BY: _____ PRINTED: 04/18/2025
FORM APPROVED
OMB NO. 0938-0391DEPARTMENT OF HEALTH AND HUMAN SERVICES
CENTERS FOR MEDICARE & MEDICAID SERVICES

STATEMENT OF DEFICIENCIES AND PLAN OF CORRECTION		(X1) PROVIDER/SUPPLIER/CLIA IDENTIFICATION NUMBER: 205064	(X2) MULTIPLE CONSTRUCTION A. BUILDING 01 B. WING _____		(X3) DATE SURVEY COMPLETED 04/15/2025
NAME OF PROVIDER OR SUPPLIER ROSS MANOR			STREET ADDRESS, CITY, STATE, ZIP CODE 758 BROADWAY BANGOR, ME 04401		
(X4) ID PREFIX TAG	SUMMARY STATEMENT OF DEFICIENCIES (EACH DEFICIENCY MUST BE PRECEDED BY FULL REGULATORY OR LSC IDENTIFYING INFORMATION)	ID PREFIX TAG	PROVIDER'S PLAN OF CORRECTION (EACH CORRECTIVE ACTION SHOULD BE CROSS-REFERENCED TO THE APPROPRIATE DEFICIENCY)		(X5) COMPLETION DATE
E 000	Initial Comments Federal Recertification survey Survey Date: 04/15/25	E 000			
K 000	Ross Manor, a long term care facility, is in substantial compliance with 42 Code of Federal Regulations Part 483.73 Requirement for Long Term Care Facilities Emergency Preparedness. INITIAL COMMENTS Federal Recertification Survey: Date: 04/15/2025 Ross Manor, a Long Term Care Facility, was surveyed to the National Fire Protection Association 101 Life Safety Code

GAP90™

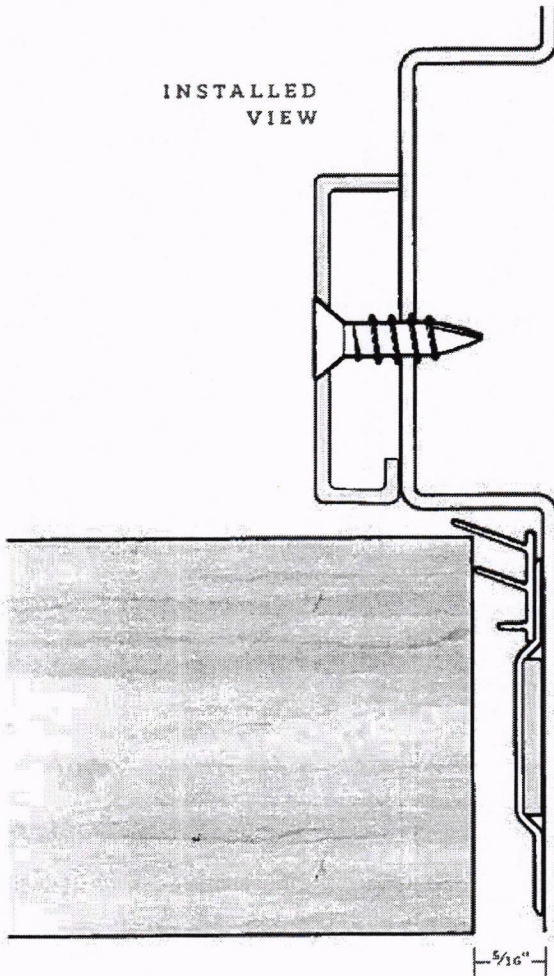
STATEMENT OF DEFICIENCIES AND PLAN OF CORRECTION		(X1) PROVIDER/SUPPLIER/CLIA IDENTIFICATION NUMBER: 205064	(X2) MULTIPLE CONSTRUCTION A. BUILDING 01 B. WING _____		(X3) DATE SURVEY COMPLETED 04/15/2025
NAME OF PROVIDER OR SUPPLIER ROSS MANOR			STREET ADDRESS, CITY, STATE, ZIP CODE 758 BROADWAY BANGOR, ME 04401		
(X4) ID PREFIX TAG	SUMMARY STATEMENT OF DEFICIENCIES (EACH DEFICIENCY MUST BE PRECEDED BY FULL REGULATORY OR LSC IDENTIFYING INFORMATION)	ID PREFIX TAG	PROVIDER'S PLAN OF CORRECTION (EACH CORRECTIVE ACTION SHOULD BE CROSS-REFERENCED TO THE APPROPRIATE DEFICIENCY)	(X5) COMPLETION DATE	
K 363	Continued From page 11 covering is not exceeding 1 inch. Powered doors complying with 7.2.1.9 are permissible if provided with a device capable of keeping the door closed when a force of 5 lbf is applied. There is no impediment to the closing of the doors. Hold open devices that release when the door is pushed or pulled are permitted. Nonrated protective plates of unlimited height are permitted. Dutch doors meeting 19.3.6.3.6 are permitted. Door frames shall be labeled and made of steel or other materials in compliance with 8.3, unless the smoke compartment is sprinklered. Fixed fire window assemblies are allowed per 8.3. In sprinklered compartments there are no restrictions in area or fire resistance of glass or frames in window assemblies. 19.3.6.3, 42 CFR Parts 403, 418, 460, 482, 483, and 485 Show in REMARKS details of doors such as fire protection ratings, automatics closing devices, etc. This REQUIREMENT is not met as evidenced by: Based on observation, the long-term care facility failed to maintain the corridor doors to resist the passage of smoke to and from the corridor as referenced by NFPA 101, Life Safety Code 2012 edition, Section 19.3.6.3. Finding: Observation and interview during a facility tour with the Management Director present on 04/15/2025, between 09:00 AM and 1:00 PM identified: 1. The door frame in Resident room 504 is bent upwards at the top. This has created a gap	K 363

K 363 SS=D	Corridor - Doors CFR(s): NFPA 101 Corridor - Doors Doors protecting corridor openings in other than required enclosures of vertical openings, exits, or hazardous areas resist the passage of smoke and are made of 1 3/4 inch solid-bonded core wood or other material capable of resisting fire for at least 20 minutes. Doors in fully sprinklered smoke compartments are only required to resist the passage of smoke. Corridor doors and doors to rooms containing flammable or combustible materials have positive latching hardware. Roller latches are prohibited by CMS regulation. These requirements do not apply to auxiliary spaces that do not contain flammable or combustible material. Clearance between bottom of door and floor	K 363	K363 <u>Corridor Doors</u> Maintenance to assess all facility doors for gaps, immediately, then monthly x 3months. Exactitude to repair warped door 504 by July 31, 2025. Results to QAPI

Install (1) NGP GAP90 UL Listed Frame Stop Height Extender to Remedy the Excessive Clearance at the Top of Door / Frame Head Caused by Lift Damage
